**Identification cards — Contactless  
integrated circuit cards — Proximity  
cards —**

**Part 2:  
Radio frequency power and signal  
interface**

**AMENDMENT 1: Limits of electromagnetic  
disturbance levels parasitically generated by  
the PICC**

Amendment 1 to ISO/IEC 14443-2:2010 was prepared by Joint Technical Committee ISO/IEC JTC 1, *Information technology*, Subcommittee SC 17, *Cards and personal identification*.

Figure 18 — Illustration of allowed EMD spikes

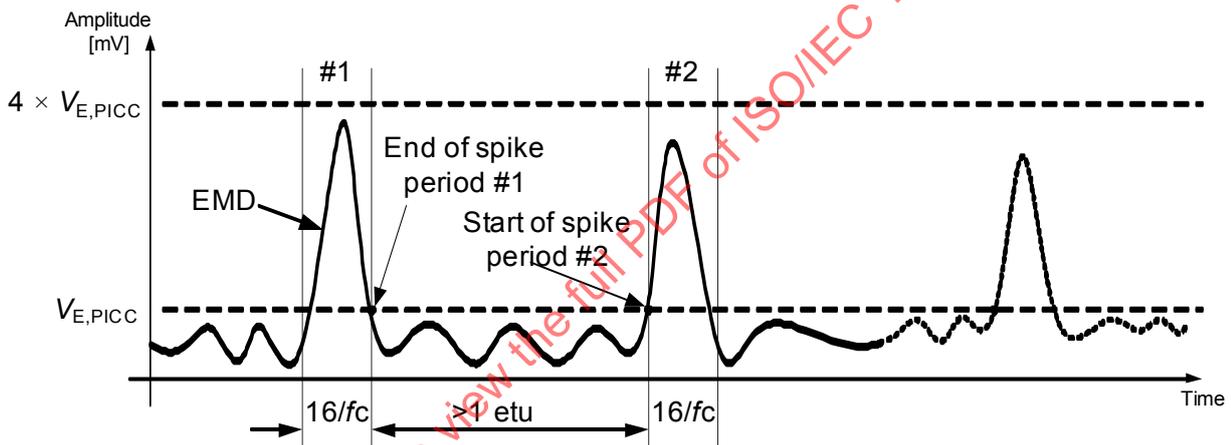
During this low EMD time, the EMD level may exceed  $V_{E,PICC}$  for no more than two short periods of  $16/fc$  if:

- it never exceeds  $4 \times V_{E,PICC}$  and
- in case of two periods, the time between the two periods is greater than 1 etu.

Figure 18 shows an illustration of such allowed EMD spikes.
